**Addendum to Remedial Action Options Report (RAOR) and Pre-Design Sampling Work Plan - Connell Aluminum Properties, LLC  
Former Koppers Tar Plant and Wabash Alloys Site  
9100 S. 5<sup>th</sup> Avenue, Oak Creek, WI 53154  
BRRTS# 02-41-553761, FID#241379050  
Connell VPLE BRRTS #:06-41-560068**

March 13, 2020

**City of Oak Creek Utility Corridor Lot 1  
9170 South 5<sup>th</sup> Avenue, Oak Creek, WI 53154  
BRRTS#: 02-41-561425, FID #:341074470  
VPLE BRRTS#: 06-41-561426**

This Addendum letter addresses the WDNR's comment letter dated October 25, 2017 provided to Connell regarding *Review of Site Investigation and Remedial Action Options Reports, Former Koppers Tar Plant and Wabash Alloys Facility*. Reference is made in this letter report and/or on attached figures to the remedial actions proposed to be completed by Beazer East, Inc. including DNAPL tar removal, and barriers for PAH-contaminated soil using soil cover or potentially mobile tar capping using geomembrane.

**FIGURE 5**  
FIGURE 8 (REV. RAOR REPORT)

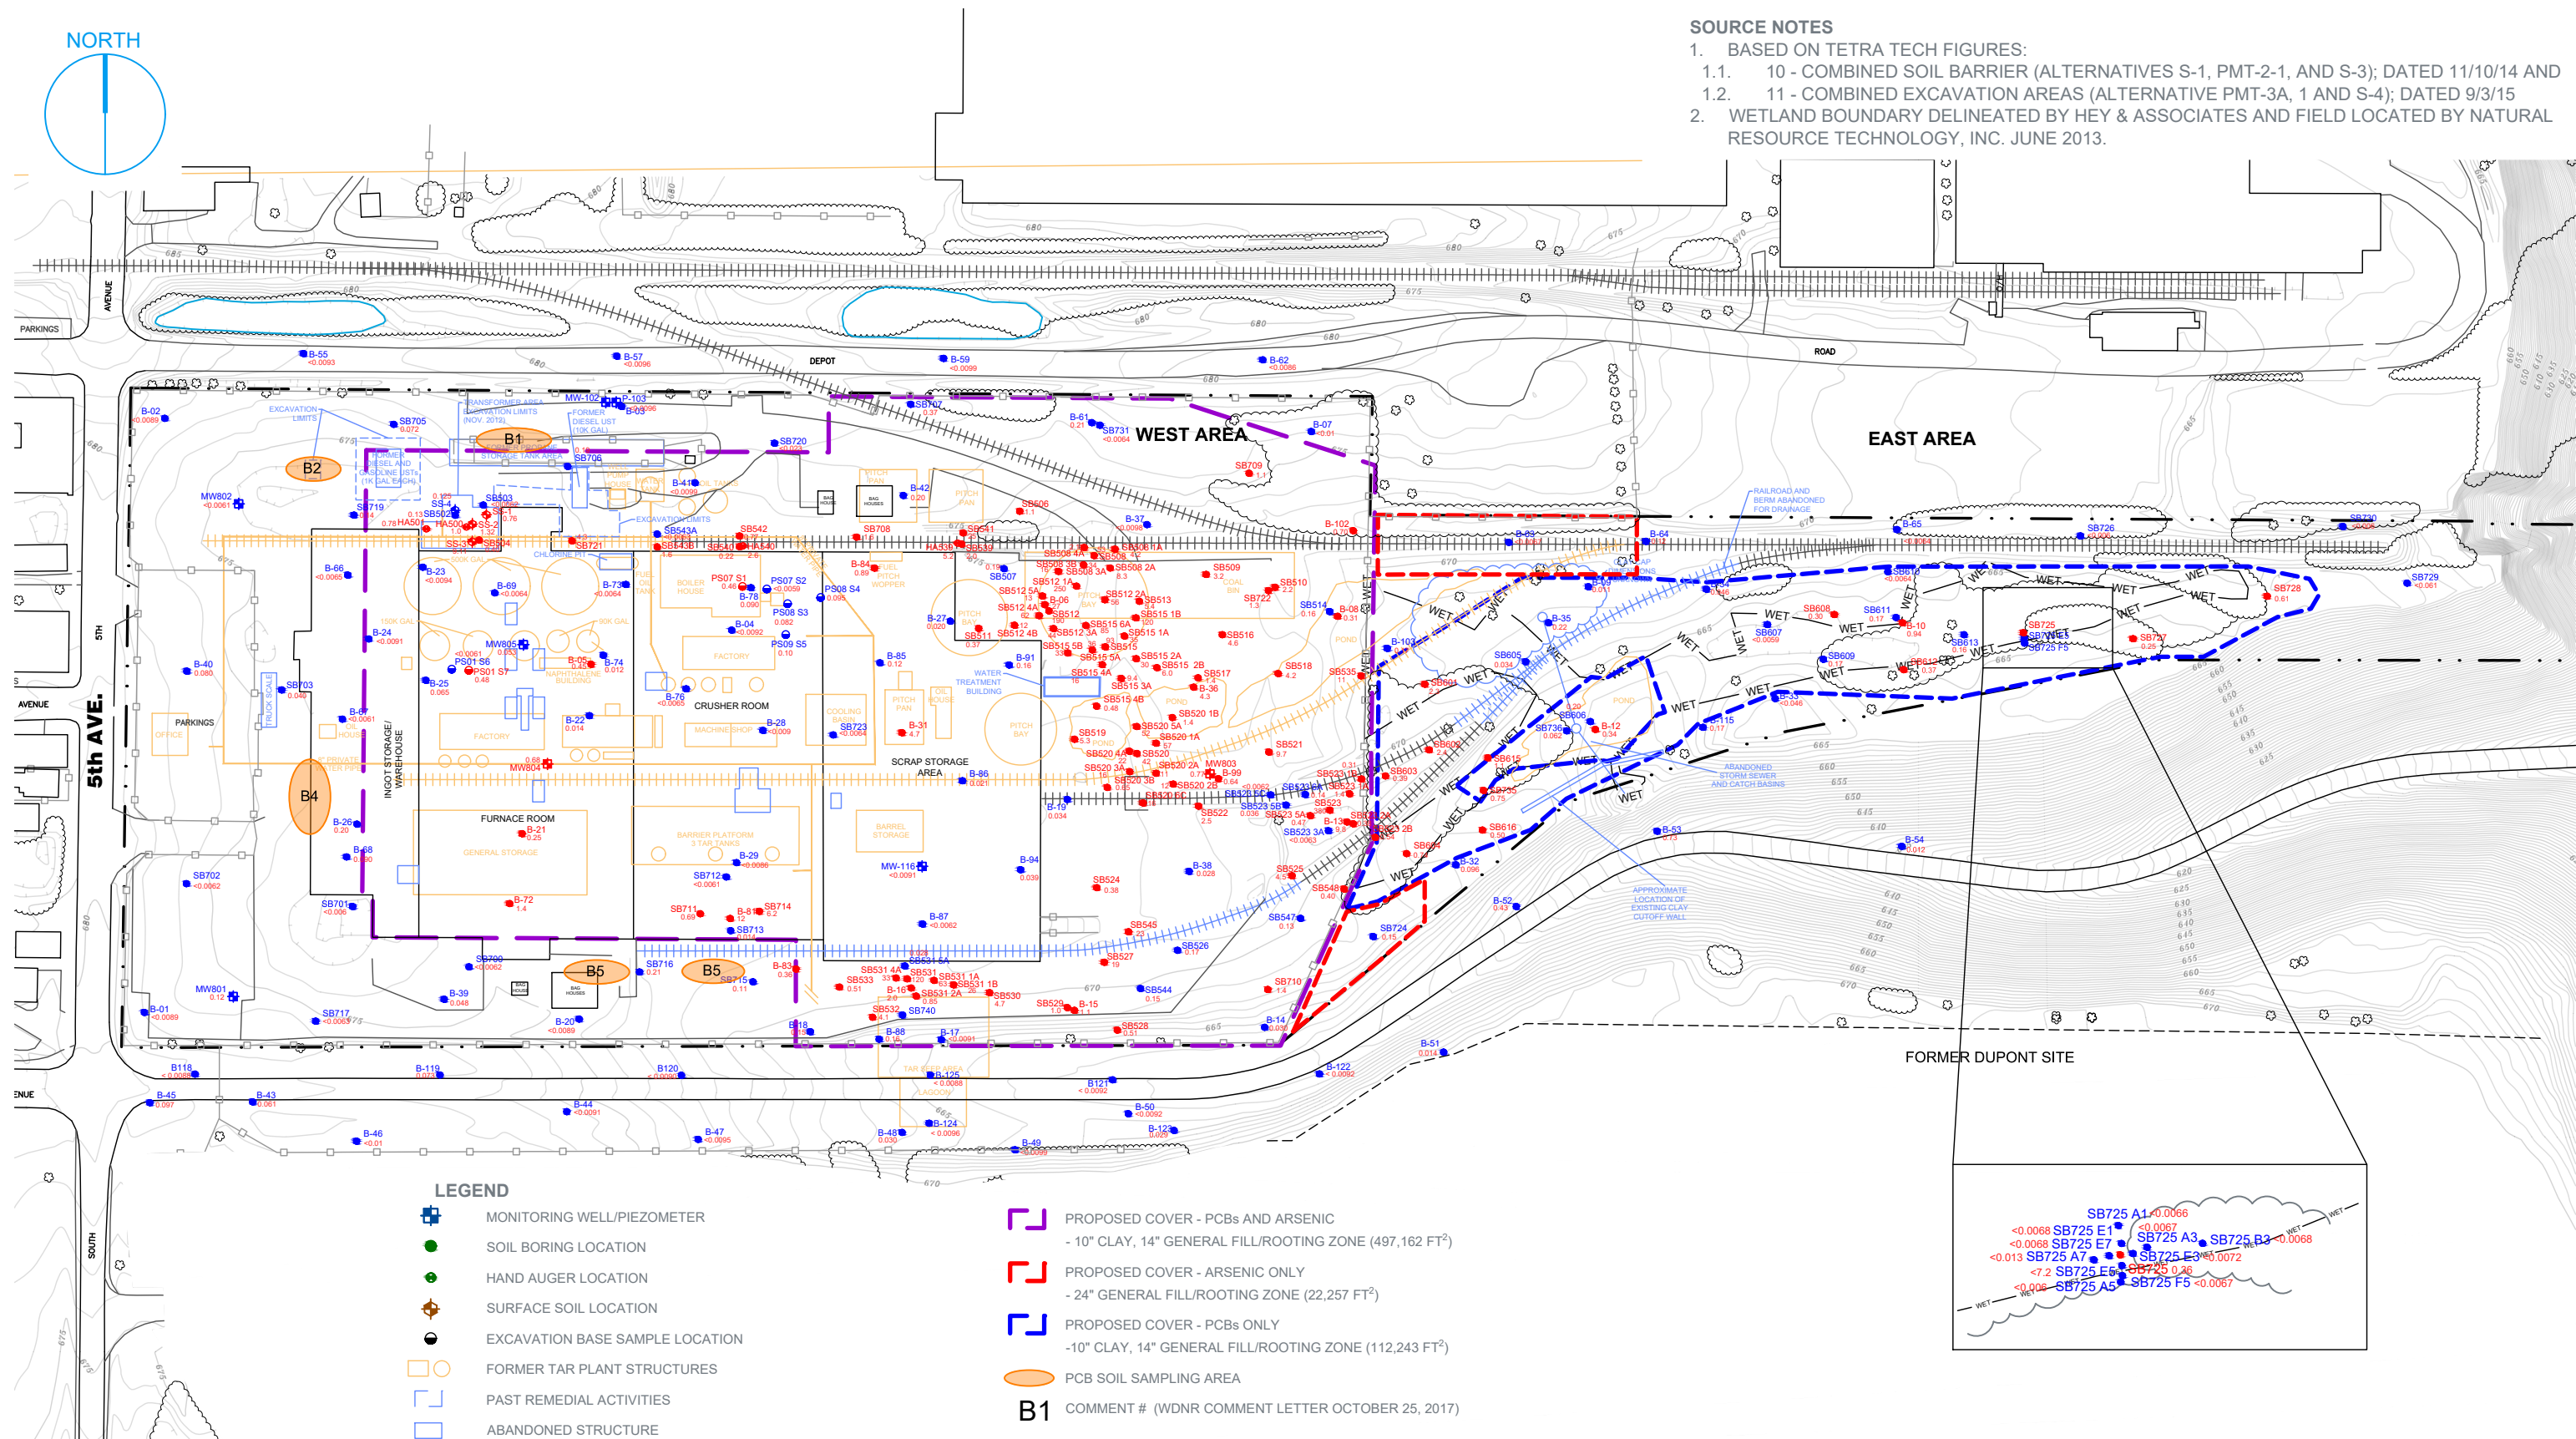
- Figure 5 – Revised RAOR Figure 8 - PCB and Arsenic Soil Barrier (Alternative S-3) for purposes of showing the revised estimated cap extent in both the western and eastern areas.
- Figure 6 – Revised Figure C35 SI Report – PCB Aroclor 1242/1248/1254/1260 Soil Concentrations (0-4 feet bgs) for purposes of showing more specifically the additional PCB sampling locations related to comments B1, B2, B4 and B5.
- Figure 7 – Revised Figure C1 SI Report – Arsenic Soil Concentrations (0-4 ft bgs) for purposes of showing more specifically the additional arsenic sampling location related to comment B3.

**FIGURE 8**

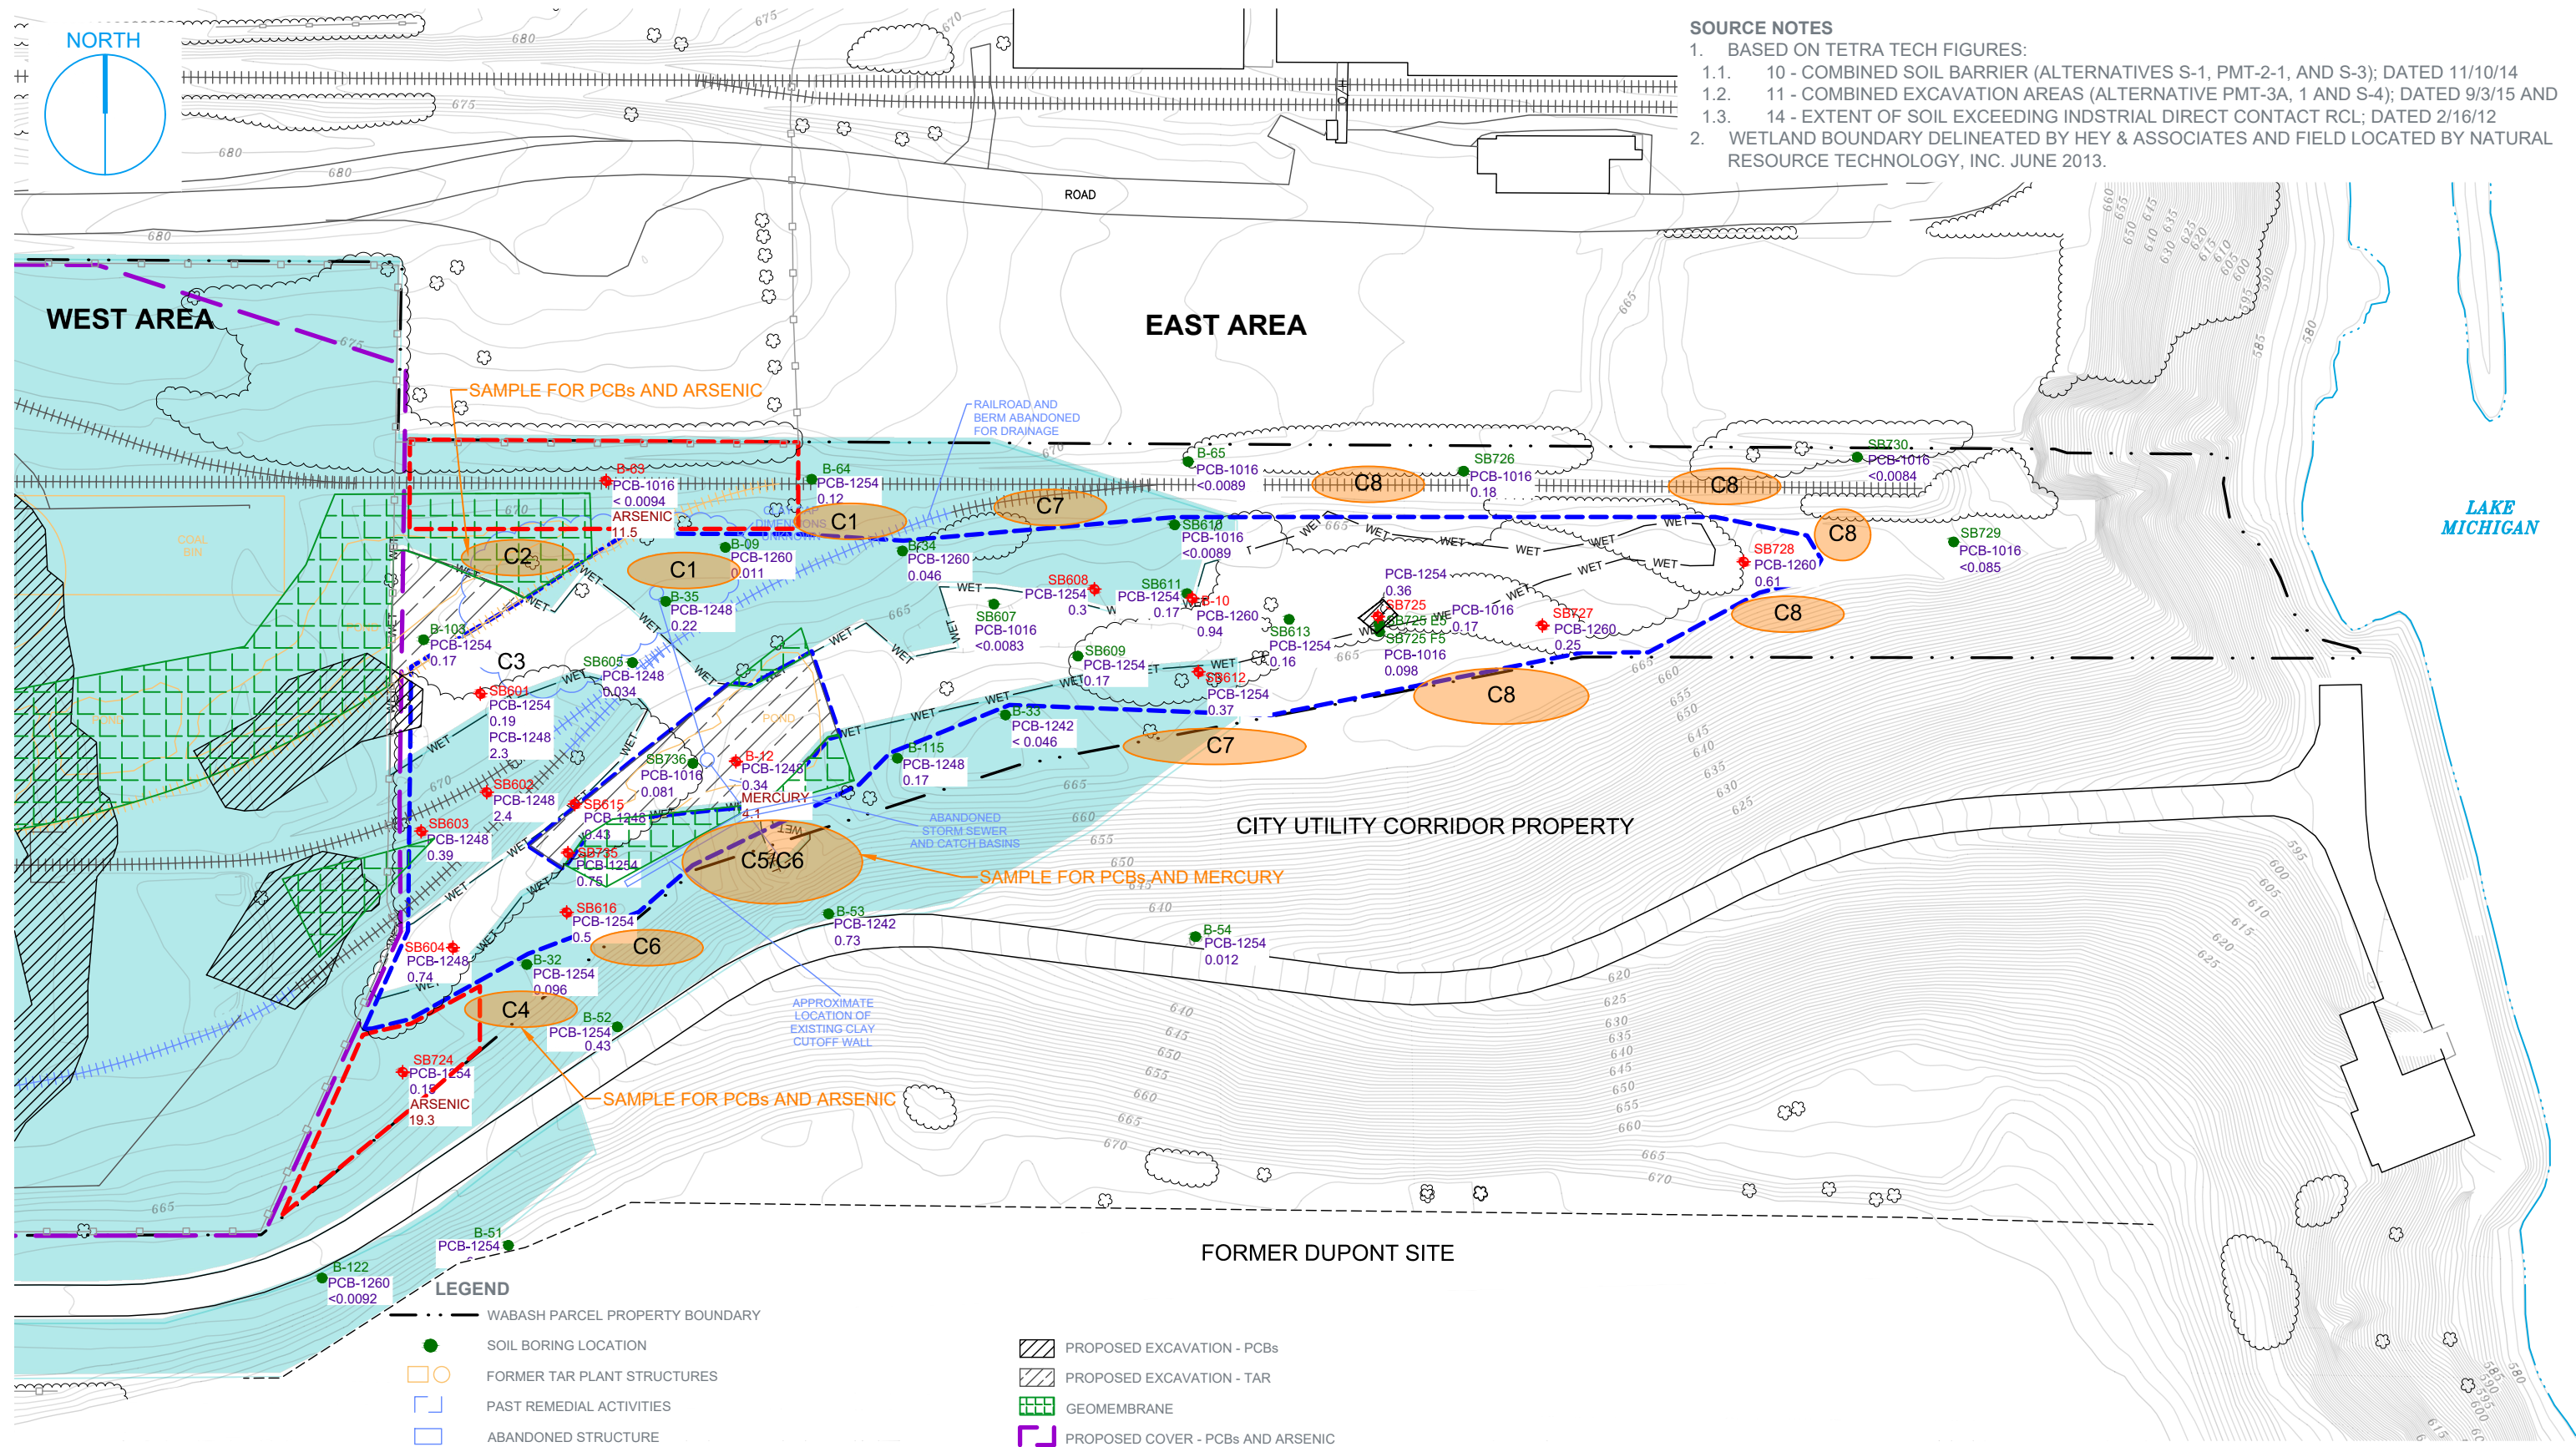
Ramboll has prepared a new figure (Figure 8) to illustrate the additional proposed capping extent in the eastern area, to include both wetland and non-wetland areas that exceed respective non-industrial RCLs.

- Figure 8 – PCB and Arsenic Soil Barrier – East Area for purposes of showing the additional proposed cap extent and the additional PCB, arsenic and mercury sampling locations related to comments C1 through C8. Sampling locations related to comments C4, C5, C6, C7 and C8 are likely to be performed on the City Utility Corridor property, and as such, access for these will be requested from the City.
